DEPARTMENT OF WATER RESOURCES

RE: Water Right Permit No. 02-7431

STATE OF IDAHO
DEPARTMENT OF WATER RESOURCES
BENEFICIAL USE FIELD REPORT

Permit No: 2-7431
Exam Date: 6/4/2013

2-7431 Beneficial Use Field Report System Diagram & Map

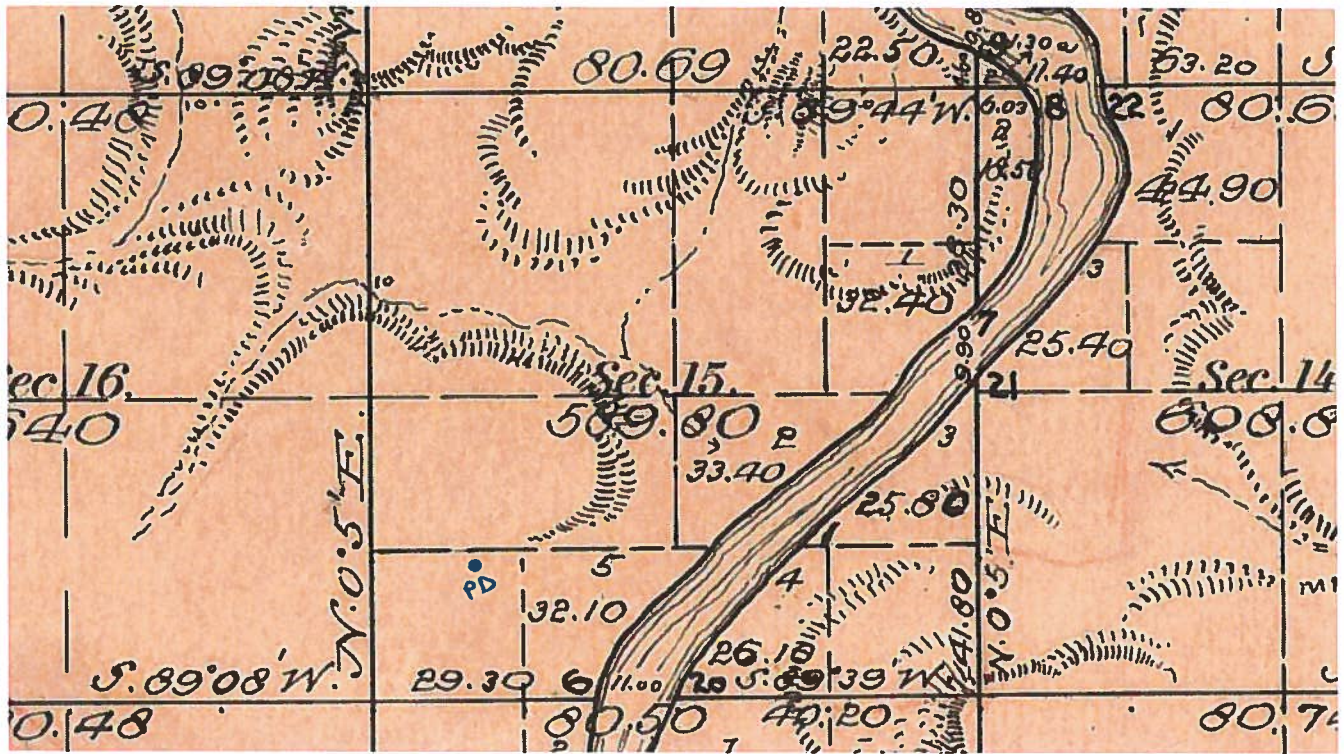
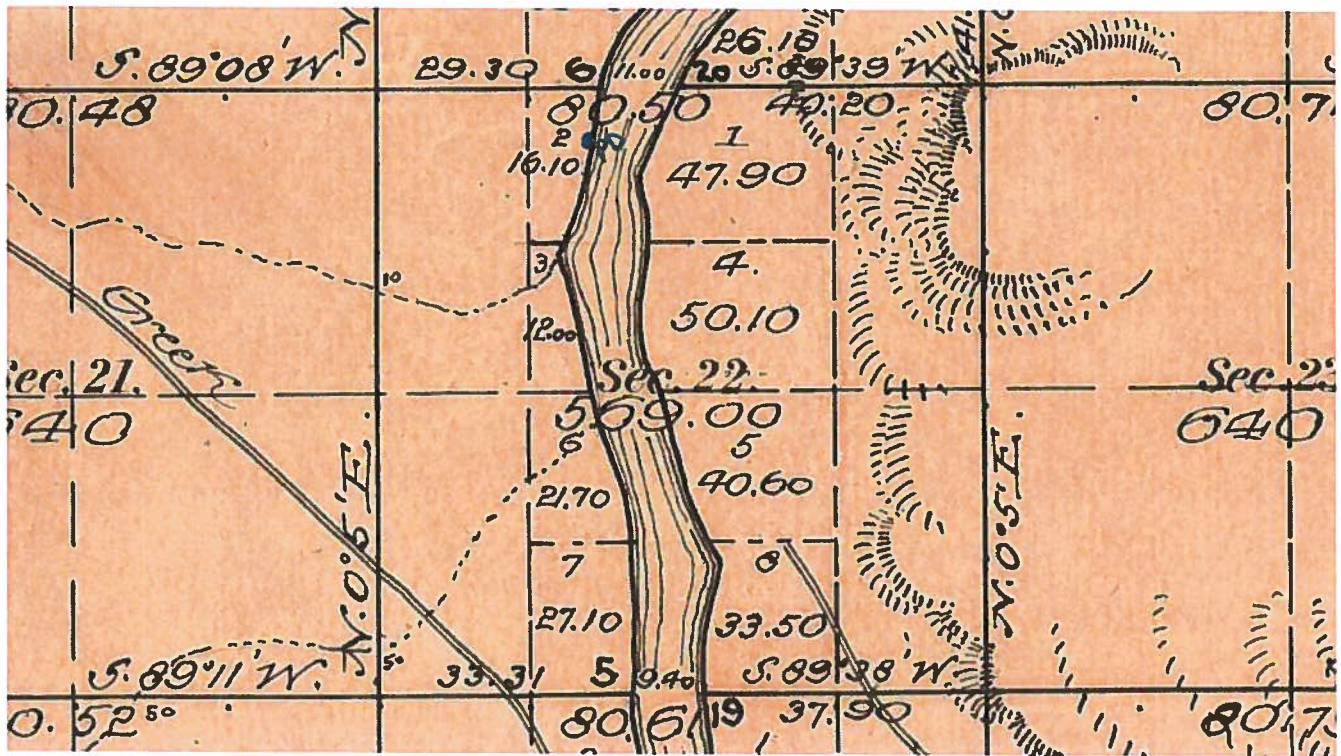
System consists of a 15 ft high dam built in a natural, otherwise dry, draw adjacent to Jackass Butte. The reservoir is filled by diversions from a wastewater ditch and the Snake River. The PODs and system also serve rights 2-2384, 57-7186, and 57-7222 for irrigation of 424 acres and additional wildlife/aesthetic uses associated with the reservoir. The POD on the Snake River has 2 motors/pumps that the permit holder typically runs one at a time. The discharge pipe(s) run into a 14 inch line that pipes water up to the wastewater POD location where it connects to a 4 inch line that diverts water into the reservoir. Wastewater at the other POD is diverted into a vault directly adjacent to the ditch where up to 3 pumps/motors can be used to divert water to the system. One of the 6 inch discharge lines runs into a 4 inch line that pipes water to the reservoir (connects to the 12 inch line coming from the Snake River). See System Diagram for details.
